TT401: XL Mirror Stem Protective Cap

March 25, 2009

APPLIES TO	SYMPTOMS
2009 Sportster models	<ul style="list-style-type: none">• Part Availability, Installation or Fitment Updates• Literature Updates or Corrections

Tech Tip 401

Figure 1. XL Mirror Stem (protective cap removed)

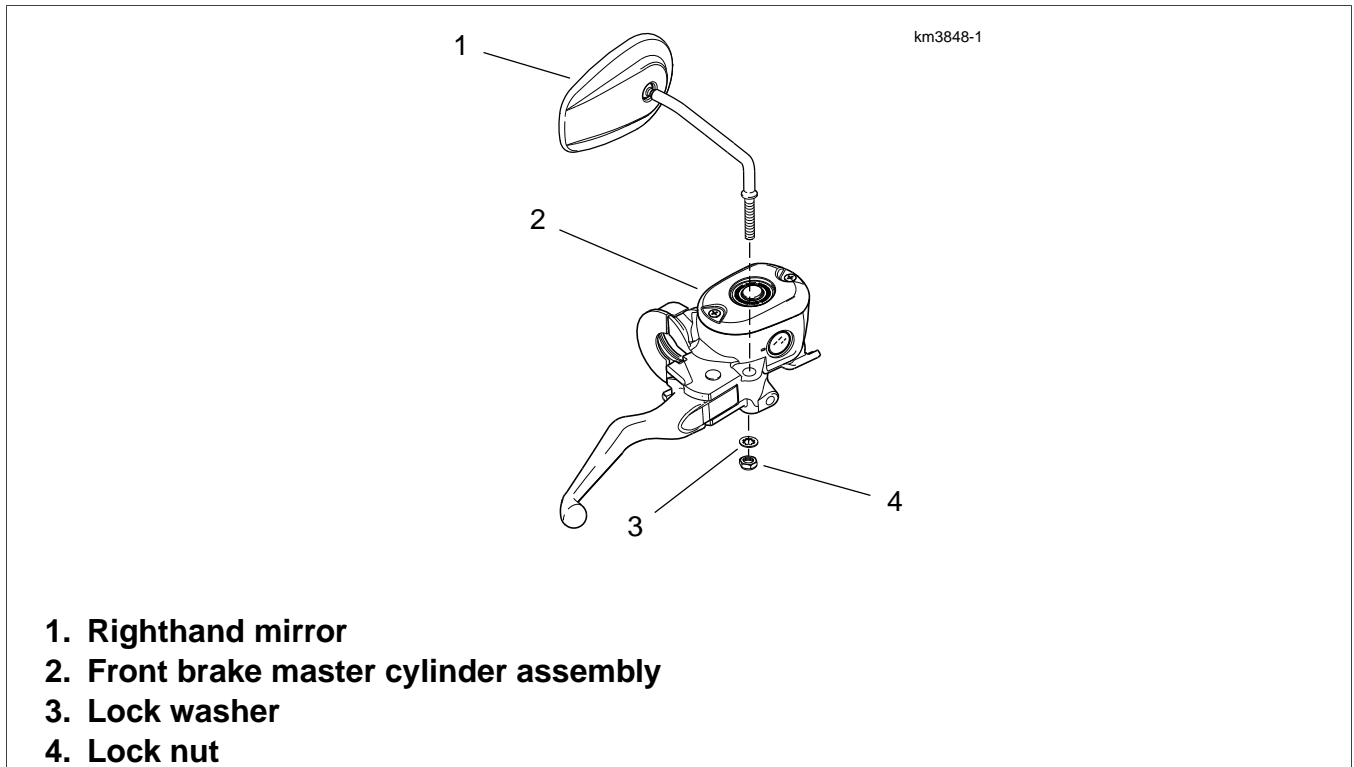
Recently, Harley-Davidson has changed the installation procedure for the mirrors on XL models. The protective cap, part number 8908, which was installed on the mirror stem threads is no longer required and has been eliminated. A new, taller locknut, (part number 7725) which provides additional thread engagement, eliminates the need for the protective cap.

Please update the 2009 Sportster Model PDI manual to reflect that NO protective cap is required. The "HEADLAMP & MIRROR" section of the 2009 Sportster Parts Catalog should also be corrected to reflect the running change.
